Spit Bridge to Neutral Bay  
B-Line Road Infrastructure  
Submissions Report

Prepared by AECOM and Roads and Maritime Services

Three hundred and forty two submissions were received including 340 from the community, one from Mosman Council and one from North Sydney Council.

**Figure 2-1: Allowable traffic movements at the intersection of Spit Road and Stanton Road outside of the AM peak.**

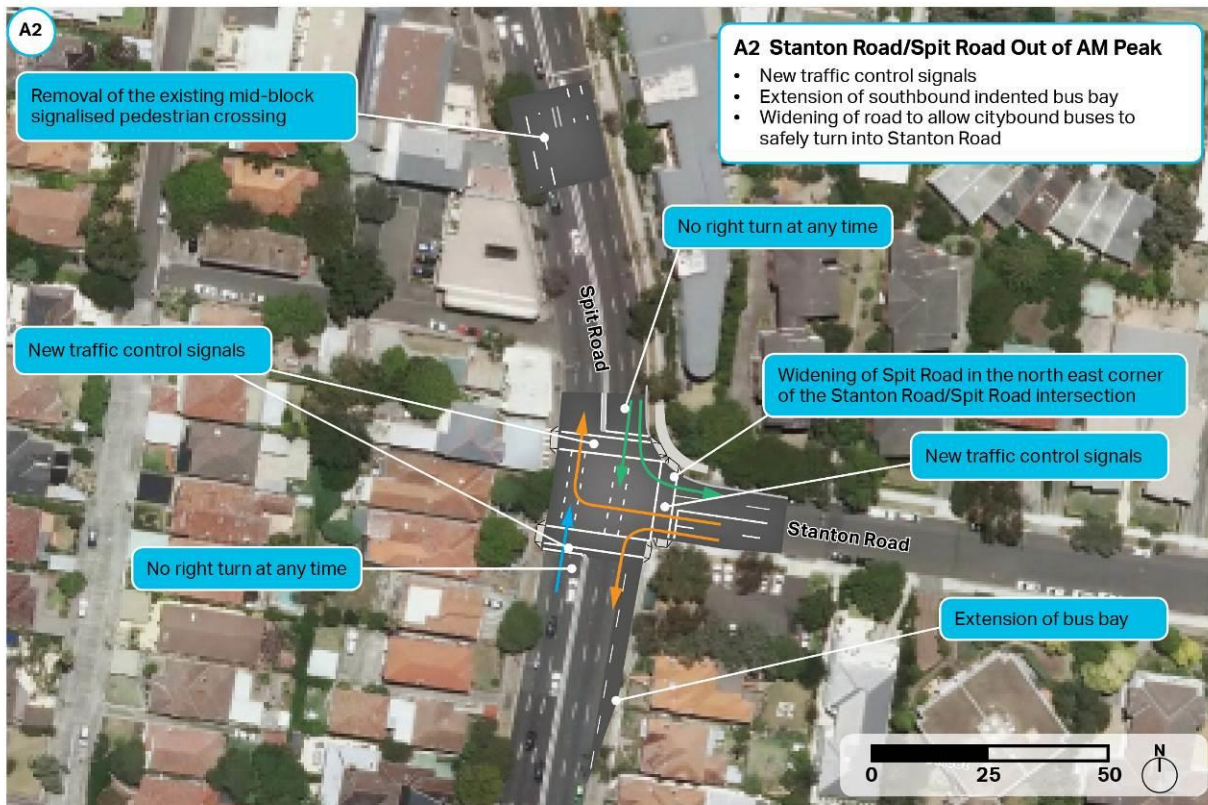
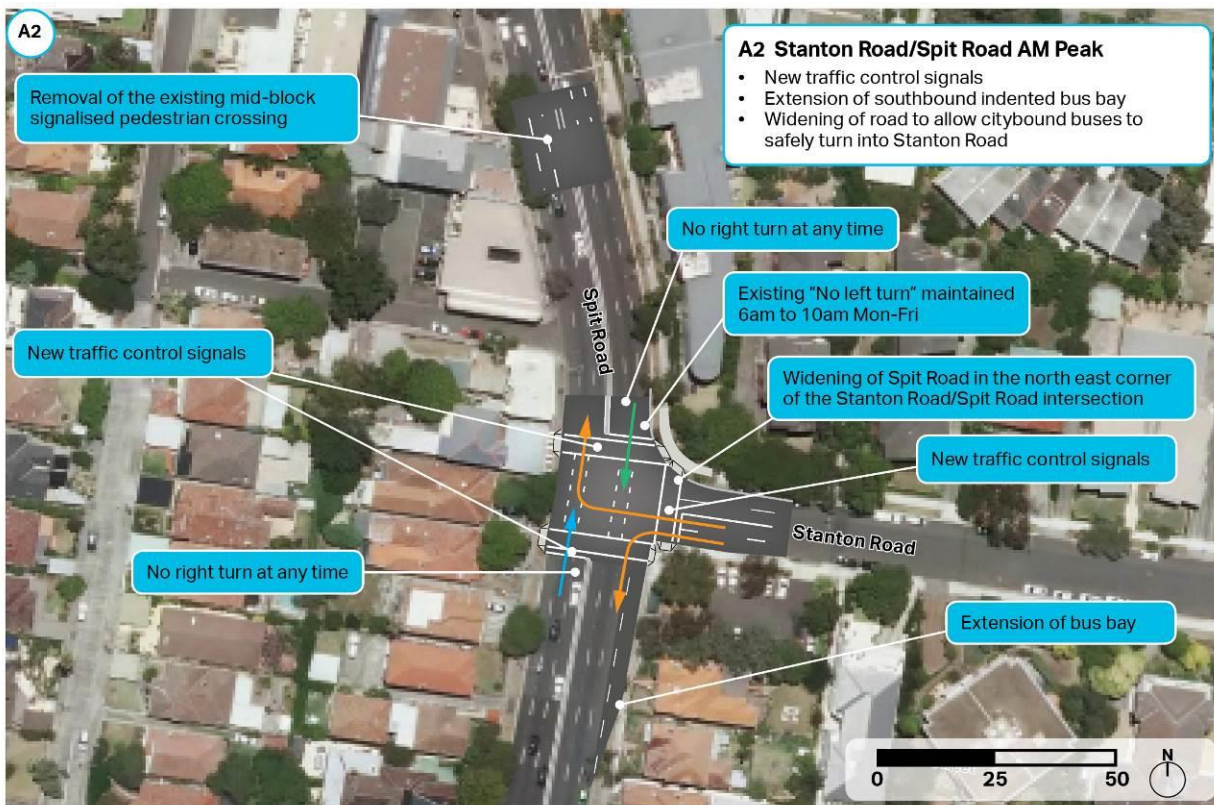
The majority of responses which mentioned Stanton Road were opposed to the proposed new traffic signals. The main concerns within these submissions related to increased traffic on Stanton Road and its associated impacts including, but not limited to, driveway access, property value, road safety and environmental/ health impacts. These are outlined in more detail below.

Figure 2-1 and Figure 2-2 illustrate the allowable traffic movements proposed at the Stanton Road/Spit Road intersection at different times of the day.

The proposal for the traffic control signals at Stanton Road is to provide an additional access point to Spit Road for traffic wishing to turn right (ie head north) from the east side of Spit Road. This is intended to relieve the existing right turn at Awaba Street that is heavily congested at numerous times across the day and at weekends. To achieve this, the existing right turn restriction out of Stanton Road onto Spit Road (outbound) during the PM peak would be removed and a signal-controlled right turn would be introduced. This is likely to result in additional traffic using Stanton Road to access Spit Road outbound. The proposed signals are not expected to introduce additional traffic turning from Spit Road into Stanton Road as the existing left turn restriction in place during the AM Peak would remain, thus maintaining the current restrictions on rat-run vehicles and minimising risk to pedestrians on local roads during this period. The number of vehicles entering Stanton Road from Spit Road outside of the AM peak would not be affected by the proposed traffic signals as this movement is already unrestricted.

The proposed traffic signals would include provision for pedestrian crossings of both Stanton Road and Spit Road. Thus the safety of pedestrians at this intersection would be improved.

Signalised pedestrian crossings would be provided on all three sides of the intersection as shown in Figure 2-1 and Figure 2-2 above. The phasing of the traffic signals would provide 'red arrow' protection for all pedestrian movements when pedestrian buttons have been pushed. The provision of traffic signals would improve the safety of pedestrians who currently have to cross Stanton Road to access the bus stop without signalised protection. The signals would also provide a direct protected crossing point for bus passengers wishing to cross Spit Road to access the bus stop on the eastern side without having to walk to the mid-block pedestrian crossing 70 metres north of Stanton Road.
